6/23/2021 7:34:06 AM RE: 35219260 (08W) - CWSP - WYANDOTTE 110932586 PH 1.1 || customer outreach

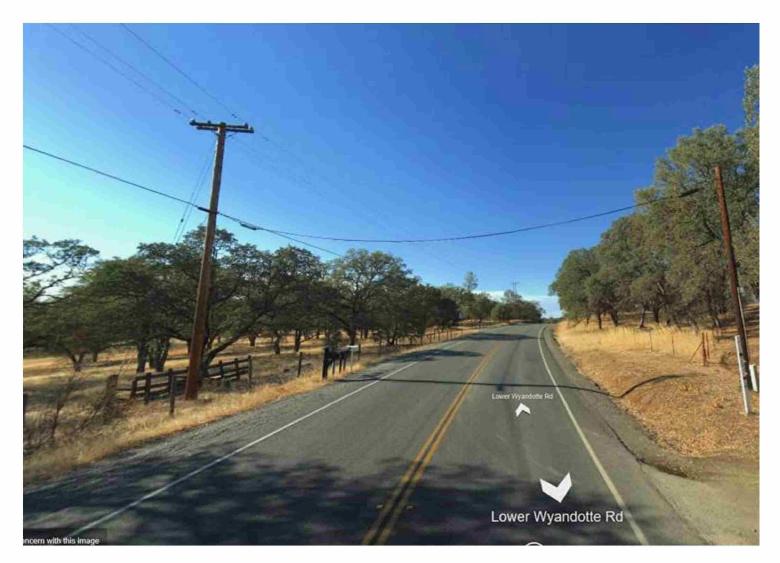
| Thanks, |
|--|
| Would it be possible to provide the coordinates for locations 29 & 30 so that solutions can stake them? |
| There is a phone pole near location 29. Was the plan to replace that with a joint pole? |

LOC 29: 39.460017, -121.511648 LOC 30: 39.460059, -121.511578

The design did not include the replacement of the joint pole show in your picture.
